U.S. Department
of Transportation
**Federal Highway
Administration**

Refer to: HSA-10/WZ-104

Thank you for your letter of October 24 requesting Federal Highway Administration (FHWA) acceptance of your company's Sentinel Type III Plastic Panel Barricade as a crashworthy traffic control device for use in work zones on the National Highway System (NHS). Accompanying your letter was a report of crash testing conducted by E-Tech Testing Services and a video of the tests. You requested that we find these devices acceptable for use on the National Highway System under the provisions of National Cooperative Highway Research Program (NCHRP) Report 350 "Recommended Procedures for the Safety Performance Evaluation of Highway Features." Mr. Nicholas Artimovich of my office gave you an initial response via fax on November 5, 2001, and asked for additional information which you subsequently provided.

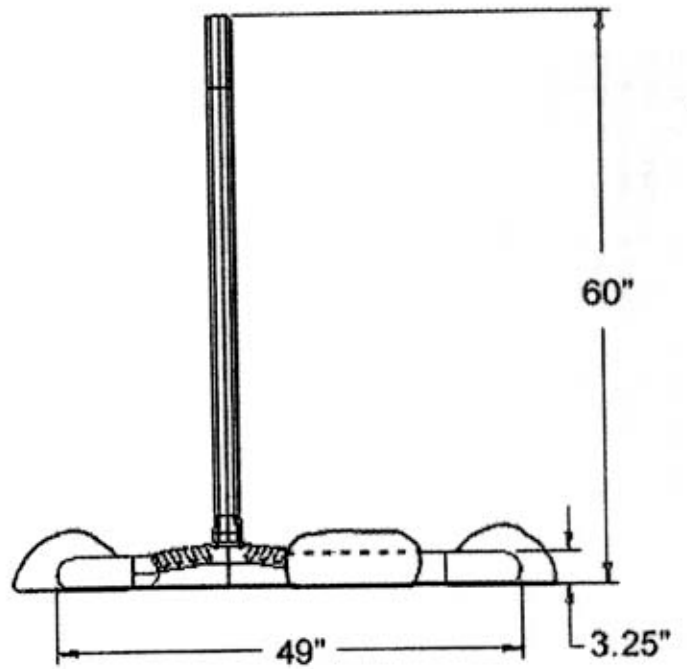
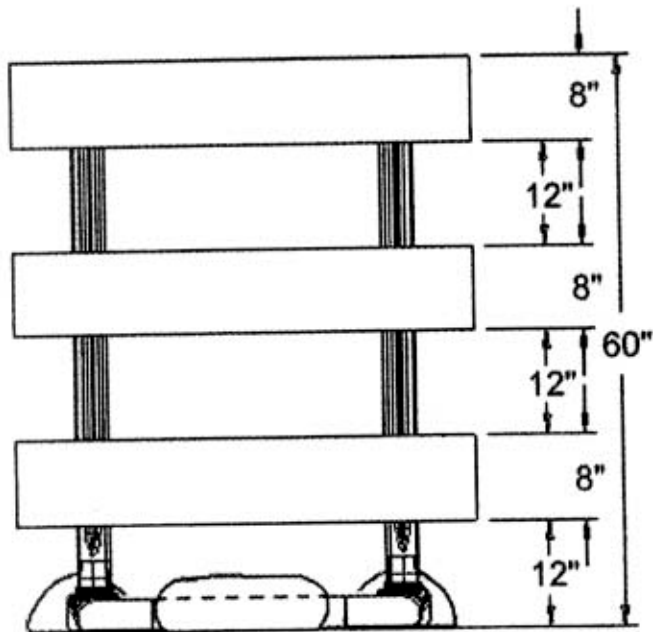
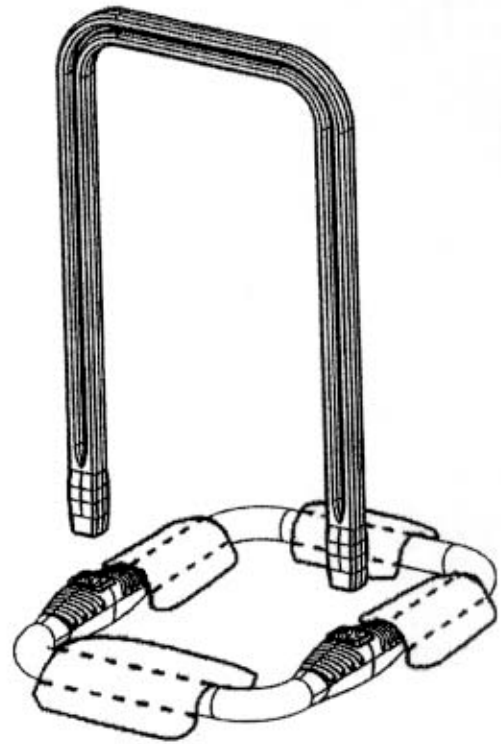
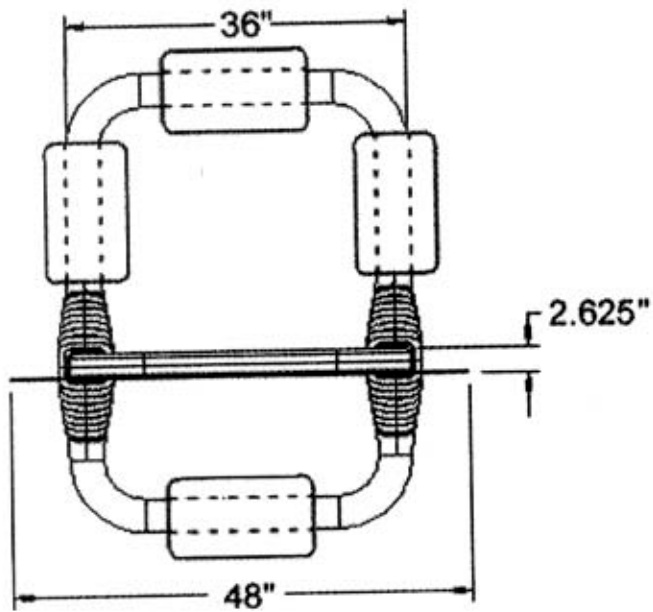
The Sentinel Type III barricade is a compact lightweight device featuring blow molded high density polyethylene upper and lower supports and hollow extruded plastic panels. The upper and lower supports are joined together with a simple slip-fit connection. The 210 mm high by 1219 mm long barricade panels are made from a specially formulated polyolefin plastic and surfaced with reflective sheeting. Each of the three panels is secured to the uprights with four 9.5 mm diameter by 76.2 mm long ASTM A307 hex bolts and nuts with plain washers front and

back. The mass of each test article was 13.4 kg. Each was placed on a flat, clean, and dry asphalt surface with three 15.9 kg sandbags placed on the lower support legs of each barricade for ballast. The complete devices as tested are shown in the enclosed drawings for reference.

When struck the upper portions of the barricades came out of the base sections and were knocked ahead of the vehicle. Damage was limited to dents and scrapes in the hood. There did not appear to be any potential for passenger compartment intrusion. The results of the testing met the FHWA requirements and, therefore, the devices described above and shown in the enclosed drawings for reference are acceptable for use on the NHS under the range of conditions tested, when proposed by a State.
